APR1400 HYDROLOGY AND METEOROLOGY CLARIFYING QUESTIONS

CLARIFYING QUESTIONS, DCD SECTION 2.3.1 AND ASSOCIATED SITE PARAMETERS

Figure 2.3-1 Locations of Post-accident Gaseous Vents and Intakes

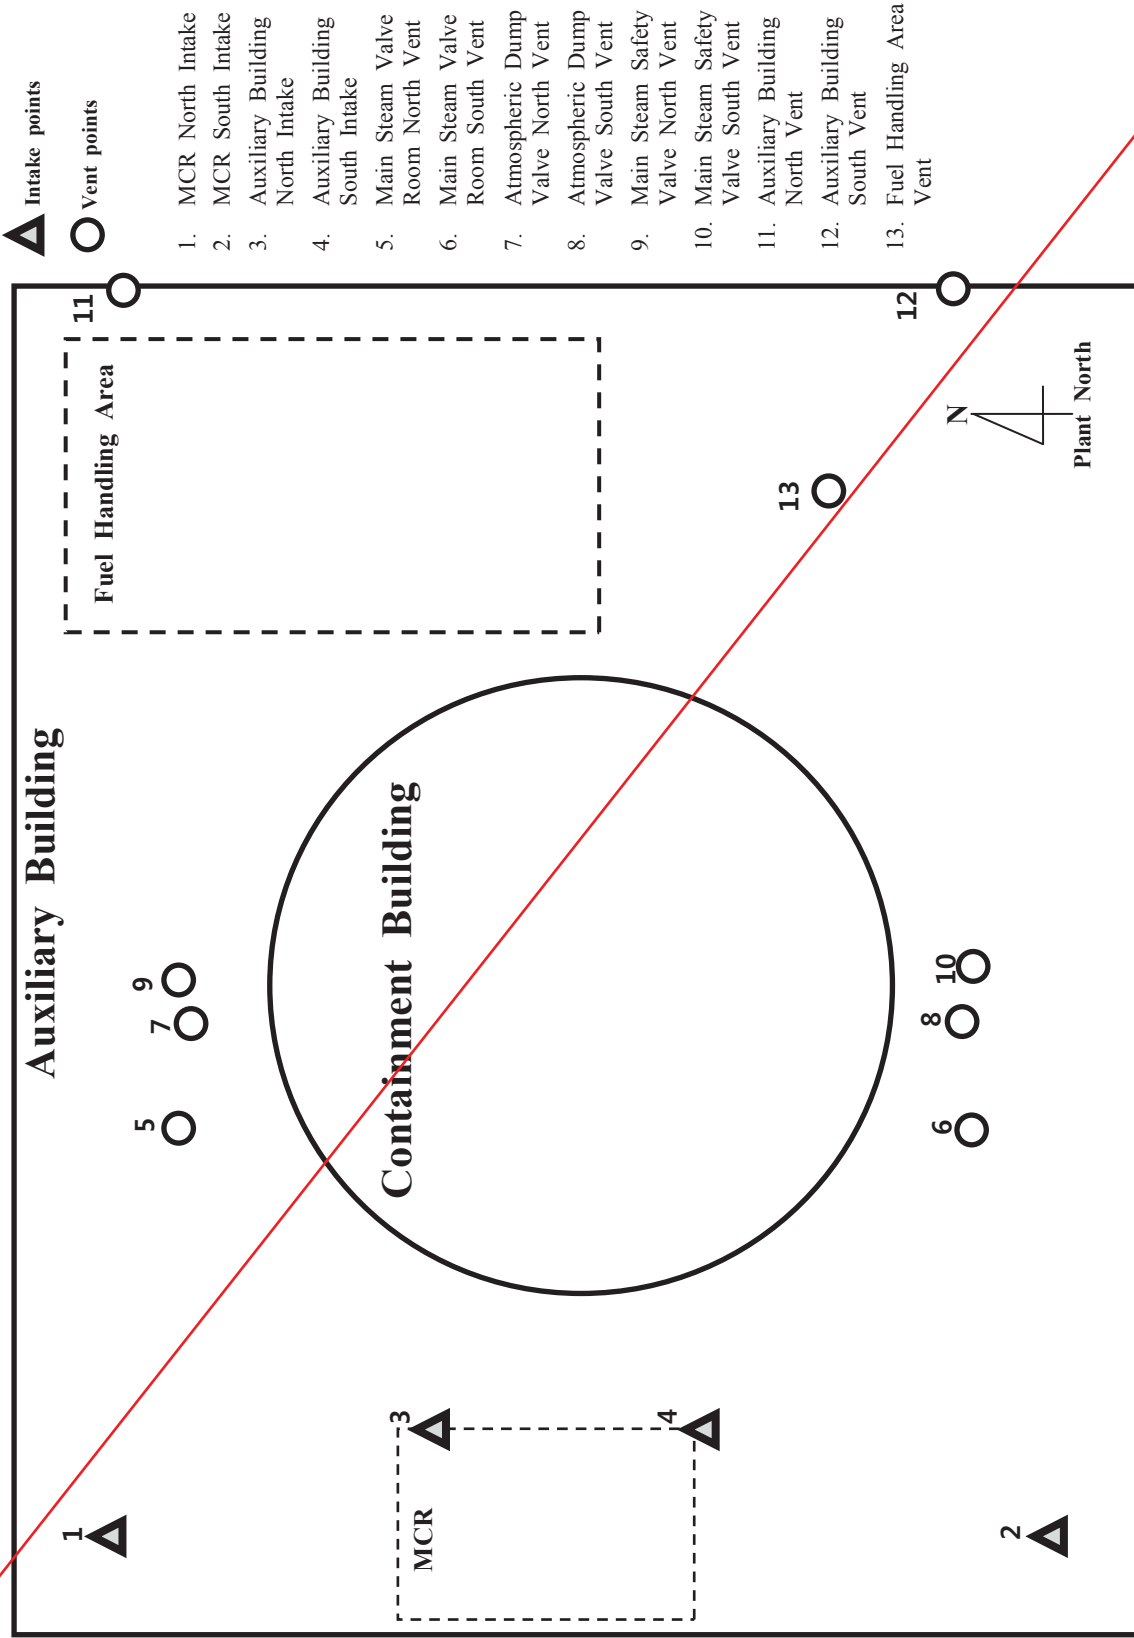
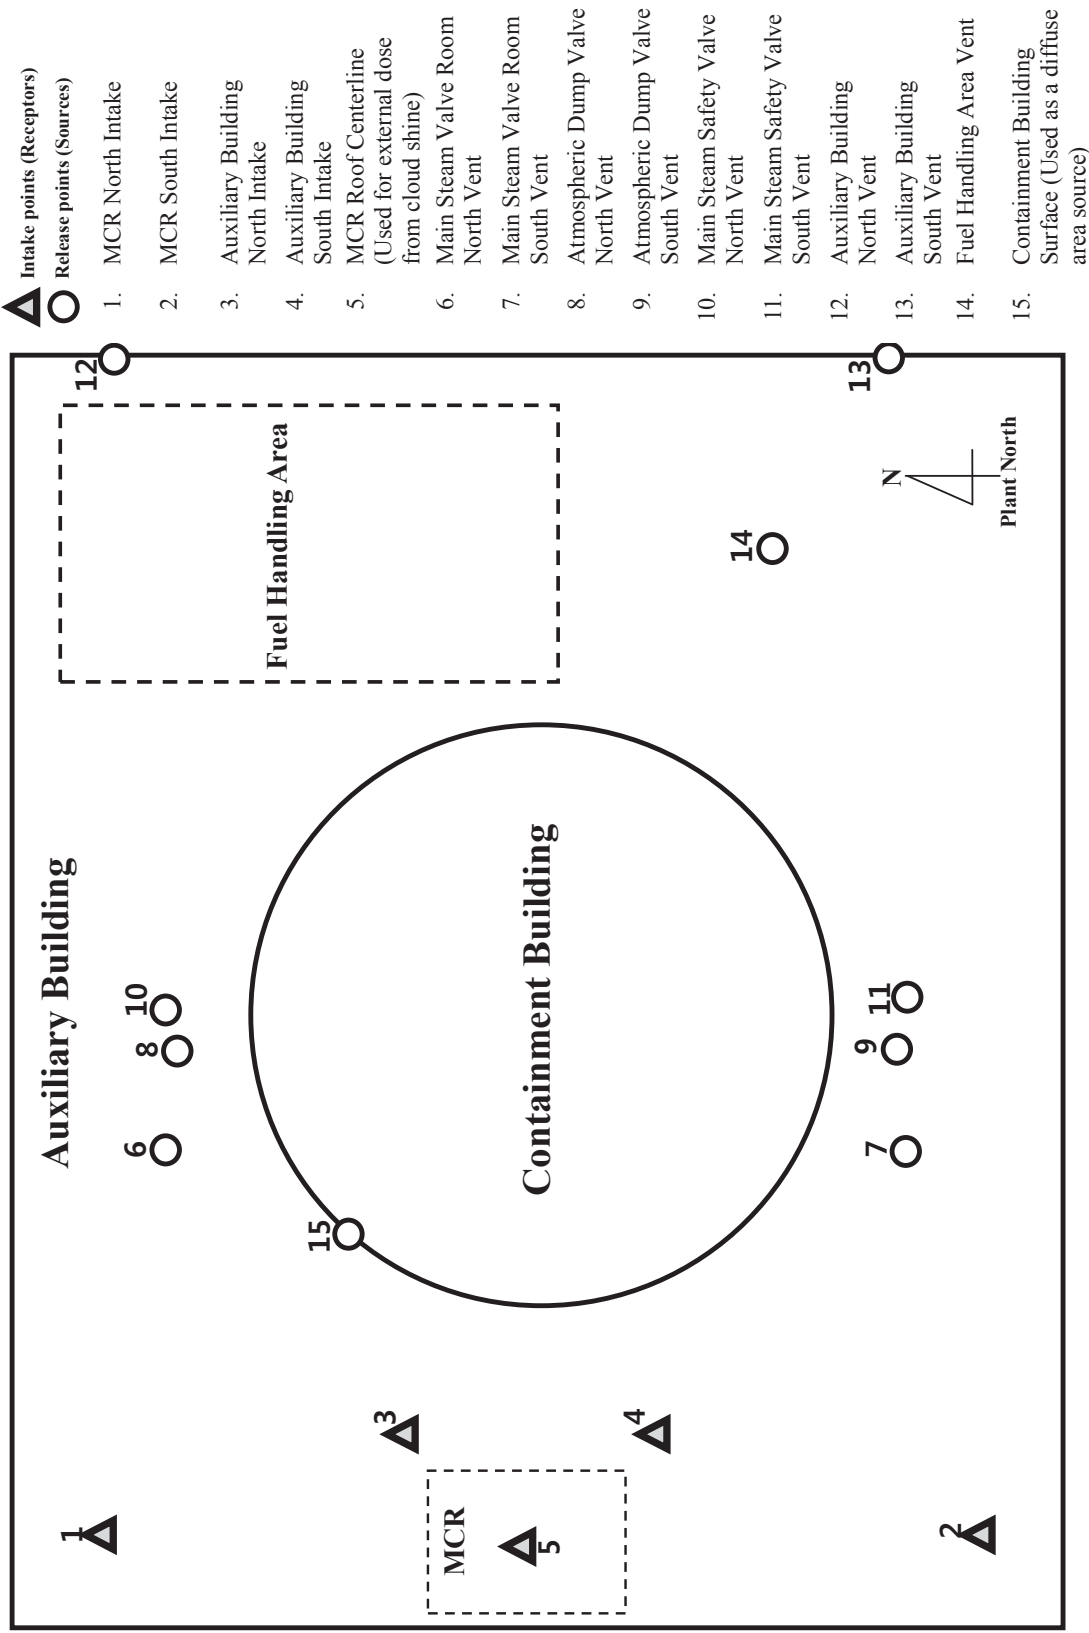
1. DCD Tier 1, Tables 2.3-2 and 2.3-13 describe an intake location with the title of “MCR Roof Centerline.” Please explain why this intake is included in these tables, as it is not included as an intake in DCD Figure 2.3-1.

2. If the “MCR Roof Centerline” is intended to be used as an intake, please update Figure 2.3-1 to include it as an intake location point.

3. DCD Tier 2, Tables 2.3-2, 2.3-3, and 2.3-13 include the Reactor Containment Building (RCB) as a vent source. DCD Figure 2.3-1 does not include the Reactor Containment Building as a vent point. Please update DCD Figure 2.3-1 to include the Reactor Containment Building as a vent point (see AP1000, Tier 2, Figure 15A-1 and Table 15A-7 (Source 8) as an example of an acceptable way to include the containment shell as a source)

APR1400 DCD Tier 2, Figure 2.3-1 lists the MCR North Intake and South Intake as intake points 1 and 2, respectively. However, in the accompanying figure, the dashed outline of MCR contains intake points 3 and 4. Please confirm if this figure is correct. If the figure is mislabeled, please correct Figure 2.3-1 in the next revision of the DCD.

Response: KHNP understands that this item relates to Tier 2, Tables 2.3-2 and 2.3-13. The control room atmospheric dispersion factor (χ/Q) for “MCR Roof Centerline” is used to calculate the external gamma dose in the MCR from the semi-infinite cloud located above the MCR roof. This information will be included in Figure 2.3-1 for consistency

Response: DCD Figure 2.3-1 will be updated to include the MCR Roof Centerline as an intake point with an added explanation. Refer to Point 5 in the attached markup 02.03.04-2.

Response: DCD Figure 2.3-1 will be updated to include the containment surface as a diffuse area source. Refer to the Point 15 in the attached markup 02.03.04-2.

Response: Intake points 1 and 2 in Figure 2.3-1 are the north and south intake locations of the MCR envelope. The intake points 3 and 4 are those used for the Auxiliary Building HVAC

systems. Figure 2.3-1 will be revised to separate the dashed outline from points 3 and 4 to avoid misunderstanding.
